## Technical Guidance Committee Meeting

### Minutes

Thursday, February 4, 2016

Figure 4-46. Cross-sectional view of a subsurface flow constructed wetland.

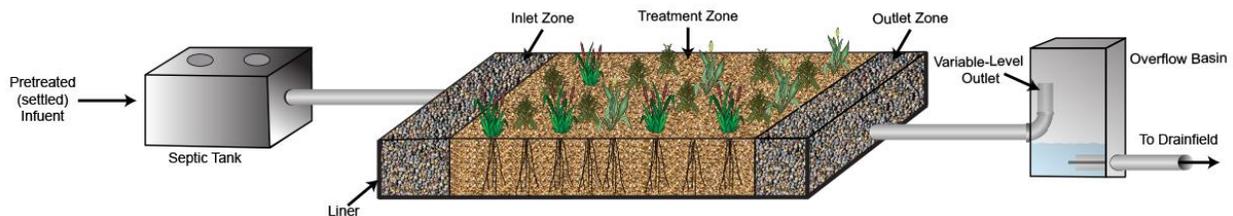
**Action Item:** Move the arrow in Figure 4-46 identifying the liner location.

**Figure 4-47. Cross sectional view of a constructed wetland cell.**

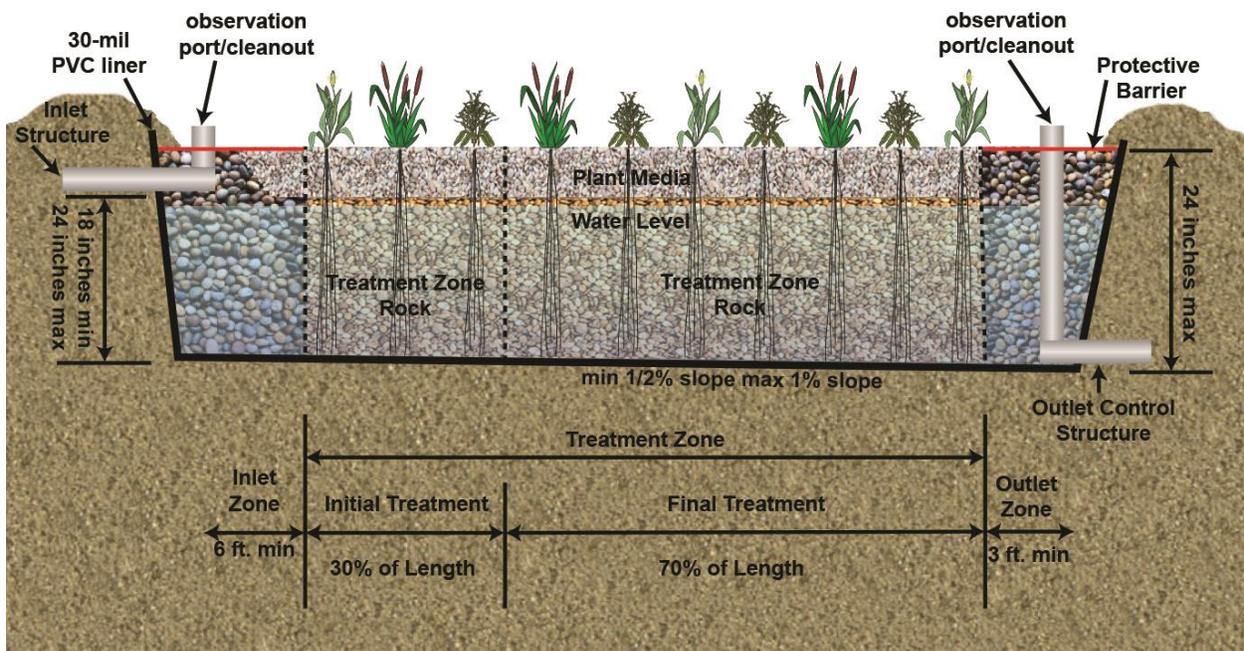
Bob Erickson had questions regarding the placement of geotextile fabric over the top of the wetland system. Mr. Erickson feels that this will inhibit the plants from growing, spreading, and reseeding. This requirement was removed from the system guidance and the committee asked that figure 4-47 be amended accordingly.

**Figure 2-4. Test hole profile used in example 2.**

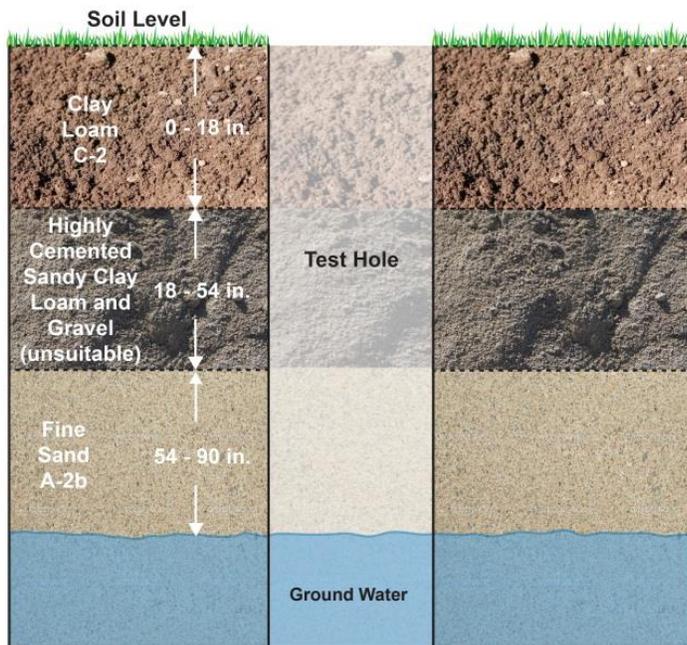
Tyler Fortunati provided the committee information that he had received several inquiries into the figure and example provided in this section and its conflict with suitable soils being at the sidewall of the drainfield in conformance with IDAPA 58.01.03.008.02.b. Mr. Fortunati drafted this proposal in response to those inquiries for TGC discussion.

Mike Reno informed the committee that if this change is approved it will cause a large number of systems located in Ada County to be non-conforming due to the issues they have with hardpan and cemented soils in the county. Mr. Reno stated that it is common practice in District 4 to permit systems where they excavate through thick soil layers that would be considered unsuitable to reach suitable soils and backfill with medium sand. Mr. Reno stated that in many cases there is not enough suitable soils in the upper soil profile to get the drainfield sidewalls within suitable soils.

Dale Peck agreed with Mr. Reno and stated that District 1 would have the same issue over the aquifer area due to coarse soils. Tyler Fortunati stated that the in-trench sand filter section of the TGM specifically has an allowance to replace the coarse sands with medium sand so the drainfield is surrounded by suitable soils. Mr. Fortunati stated that the section did not address scenarios described by Mr. Reno and likely needed to.

**Figure 4-35. Effluent return locations and ratios from the recirculating gravel filter and flow splitter for systems treating total nitrogen.**

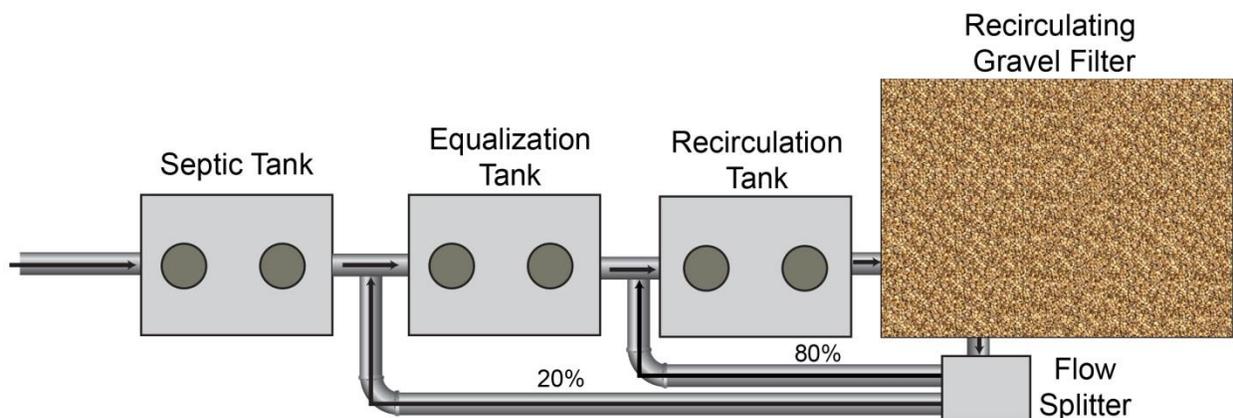
Tyler Fortunati presented a revision to the recirculating gravel filter system design that required effluent return from the filter to an equalization tank that also receives clarified effluent from a septic tank as requested by the committee at the July meeting. A new flow splitting device was also added to the design guidance.

Joe Canning had questions on the flow splitting and effluent return. Tyler Fortunati stated that the ratios included in the guidance were based on the requirements used by other states and EPA design guidance. Tyler Fortunati also stated that the flow splitting for effluent return was to be determined by the design engineer.

1. Effluent shall be returned from the recirculating gravel filter in a ratio of 20% to the equalization tank and 80% to the recirculation tank (Figure 4-35).
2. Effluent return from the filter to the equalization tank and recirculation tank may be done by gravity or under pressure.
3. The design engineer must specify how the return ratio will be met with the system design and document the return flow in the system design calculations.
